2 SITE CHARACTERISTICS AND SITE PARAMETERS

This chapter of the safety evaluation report (SER) documents the U.S. Nuclear Regulatory Commission (NRC) staff's review of Chapter 2, "Site Characteristics and Site Parameters," of the NuScale Power, LLC (hereinafter referred to as "the applicant"), Design Certification Application (DCA), Part 2, "Final Safety Analysis Report (FSAR)." The Phase 2 SER for this chapter (ML18214A195) identified one Open Item (OI), which the applicant addressed through information submitted on the docket. Rather than discuss the OI in this SER chapter, the staff has directly evaluated the adequacy of the information submitted on the docket to address them, which is included in the current version of the DCA. The OI has been satisfactorily closed. The staff's regulatory findings documented in this SER are based on Revision 3 of the DCA.

Figure 2.5-1 NuScale horizontal (a) and vertical (b) certified seismic design response spectra 5-percent damping (after DCA Part 2 Tier 1, Figures 5.0-1 and 5.0-2)

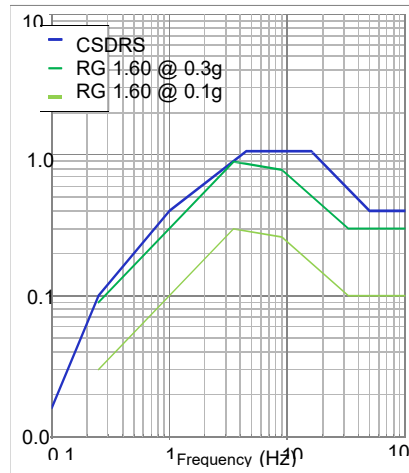
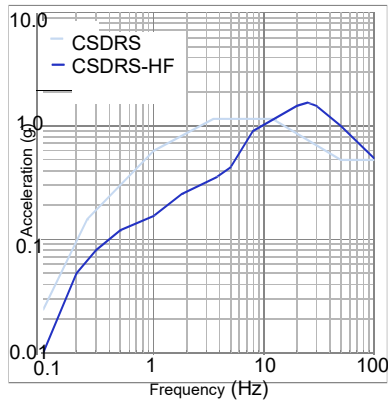
DCA Part 2 Tier 1: DCA Part 2 Tier 1, Table 5.0-1, specifies certified seismic design response spectra (CSDRS) that form the seismic loading design basis and can be used to compare with the site-specific ground motion response spectra (GMRS), and to determine the safe-shutdown earthquake (SSE). Figures 2.5 1 and 2.5 2 of this report illustrate these CSDRS.

Figure 2.5-2 NuScale horizontal (c) and vertical (d) certified seismic design response spectra - high frequency 5-percent damping (after DCA Part 2 Tier 1, Figures 5.0-3 and 5.0-4)

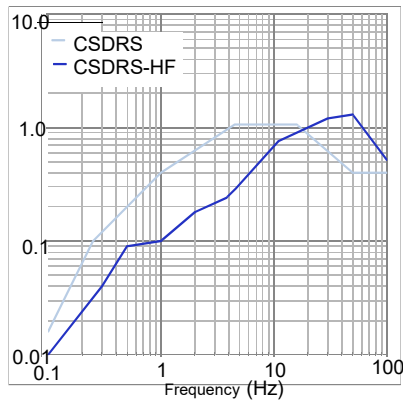
As stated in DCA Part 2 Tier 2, Section 2.5.2, the CSDRS and the CSDRS-HF are key design parameters. DCA Part 2 Tier 2, Section 3.7.1, "Seismic Design Parameters," discusses these parameters. The CSDRS is shown in Figure 3.7.1-1, "NuScale Horizontal CSDRS at 5 Percent Damping," and Figure 3.7.1-2, "NuScale Vertical CSDRS at 5 Percent Damping," and the CSDRS-HF is shown in Figure 3.7.1-3, "NuScale Horizontal CSDRS-HF at 5 Percent Damping," and Figure 3.7.1-4, "NuScale Vertical CSDRS-HF at 5 Percent Damping." Tables 3.7.1-1 and 3.7.1-2 provide the horizontal and vertical control points for the CSDRS and CSDRS-HF at 5-percent damping.
